**Sundry Notices and Reports on Wells**

<p>1. Type of Well GAS</p> <hr/> <p>2. Name of Operator Meridian Oil Inc.</p> <hr/> <p>3. Address &amp; Phone No. of Operator Box 4289, Farmington, NM 87499 (505) 326-9700</p> <hr/> <p>4. Location of Well, Footage, Sec, T, R, M. SENW                      Sec. 6 , T-25-N, R-4-W, NMPM  1540/N 1670/W</p>	<p>5. Lease Number Jic. Contract 123 C</p> <p>6. If Indian, All. or Tribe Name Jic. Apache</p> <p>7. Unit Agreement Name</p> <hr/> <p>8. Well Name &amp; Number Jicarilla 123 C #27</p> <p>9. API Well No.</p> <hr/> <p>10. Field and Pool W. Lindrith Gallup Dakota</p> <p>11. County and State Rio Arriba County, NM</p>
--	--

Jicarilla 123 C #27  
Unit F Sect 6-T25N-R4W  
Rio Arriba County, New Mexico

Wellbore Schematic

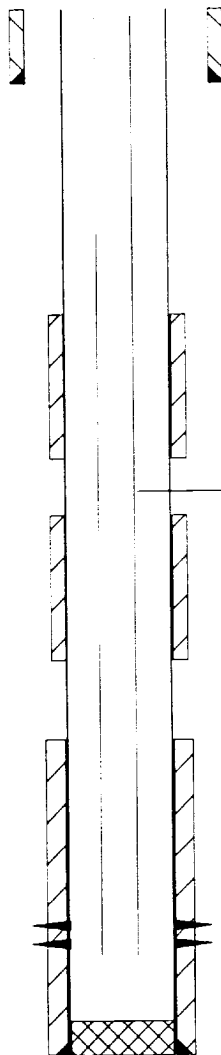
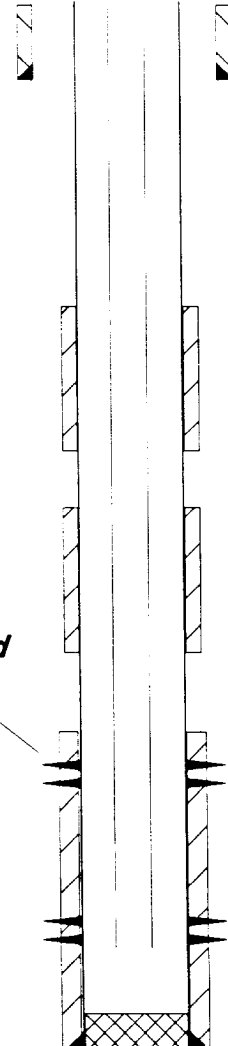
It is intended to add the Gallup interval in the subject well and commingle the production downhole. This well is in the West Lindrith Gallup Dakota commingled pool. The workover will consist of the following:

TOOH w/tbg. Set RBP @ 7100'.  
 Perf Gallup w/37 holes from 6585-6940'.  
 Stimulate Gallup w/100,000 gal. slick wtr & 106,000# 20/40 sand.  
 Flow back frac fluid and clean up well.  
 Pull RBP and land tbg @ 7600'.  
 Put well back on production.

***Gallup Completed  
from 6585-6940'***
